**SUBJECT:** Response to Request for Additional Information Related to 10 CFR 20.2002 Alternate Waste Disposal Request (CAC No. L53116)

SUBJECT: Response to Request for Additional Information Related to 10 CFR  
20.2002 Alternate Waste Disposal Request (CAC No. L53116)  
Vermont Yankee Nuclear Power Station  
Docket No. 50-271  
License No. DPR-28

**REQUEST FOR ADDITIONAL INFORMATION  
RELATED TO 10 CFR 20.2002 ALTERNATE WASTE DISPOSAL REQUEST  
FOR VERMONT YANKEE NUCLEAR POWER STATION (CAC NO. L53116)**

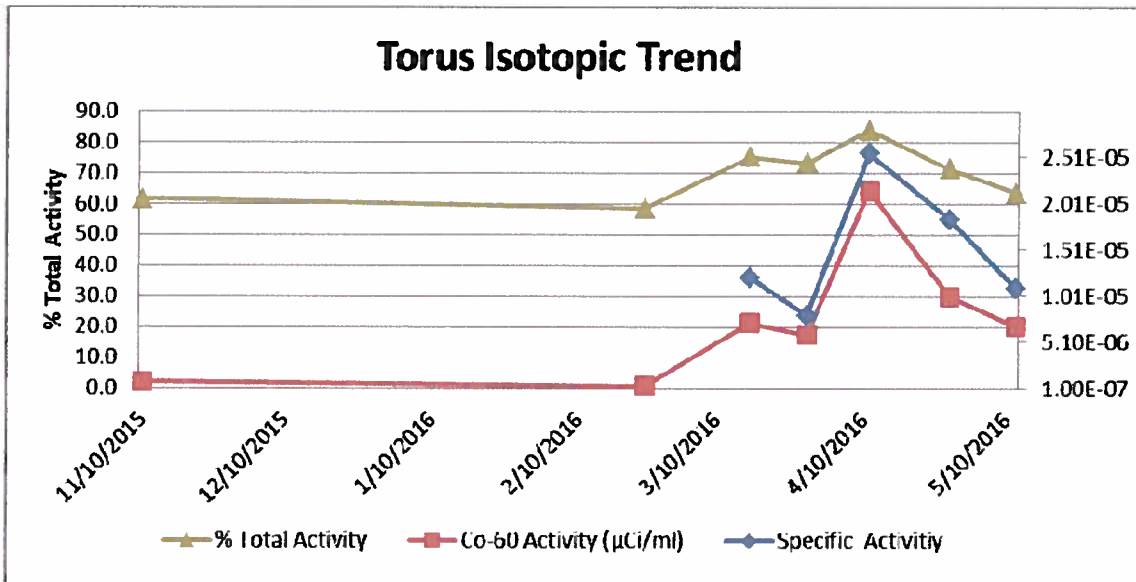
6. **Comment:** More information is needed on the characterization of the water and the uncertainty in the concentration of the radionuclides in the water.

**Basis:** The concentrations of the radionuclides in the water were based on data from a single sample. It is not clear if any other samples have been taken and, if so, what the range of concentrations observed was. Because the potential dose was estimated based only on one sample, the uncertainty in the concentrations, and therefore dose, may not have been adequately captured. Additionally, as noted in the previous comment, the reported concentration of tritium in the sample might not be representative of the actual tritium concentration.

**Path forward:** Provide information on any other samples taken of the water, including the range of concentrations observed for each of the radionuclides. Also, provide an assessment of the potential uncertainty in the concentrations, and therefore dose, as a result of basing the concentration on a single sample.

The torus water treatment system recirculates the torus volume (capacity 1.1 million gallons) approximately every 3 days, thus promoting a homogenous torus water volume. Chemistry samples showed a steady decline in anion concentration after the demineralizers were placed in service. The steady trend in anion concentrations, vice erratic results, indicates the torus water volume is homogenous. While gamma isotopic analyses have not been performed regularly and may not be useful in determining homogeneity, gross gamma measurements have consistently been < MDA for the samples analyzed (<4.3 E-06  $\mu\text{Ci/ml}$ ). If the torus water volume was not being uniformly mixed, occasional spikes in activity would be expected.

The trend above shows Co-60 activity and the percent of total activity contributed by Co-60 before and after the contents of the reactor pressure vessel were drained to the torus (during the period from early March to the middle of April). The trend data shows the total activity in the torus increased as expected when the reactor coolant was drained into the torus, and decreased as the torus demineralizers removed corrosion products from the torus water. Co-60 is the predominant isotope present before and after vessel drain.
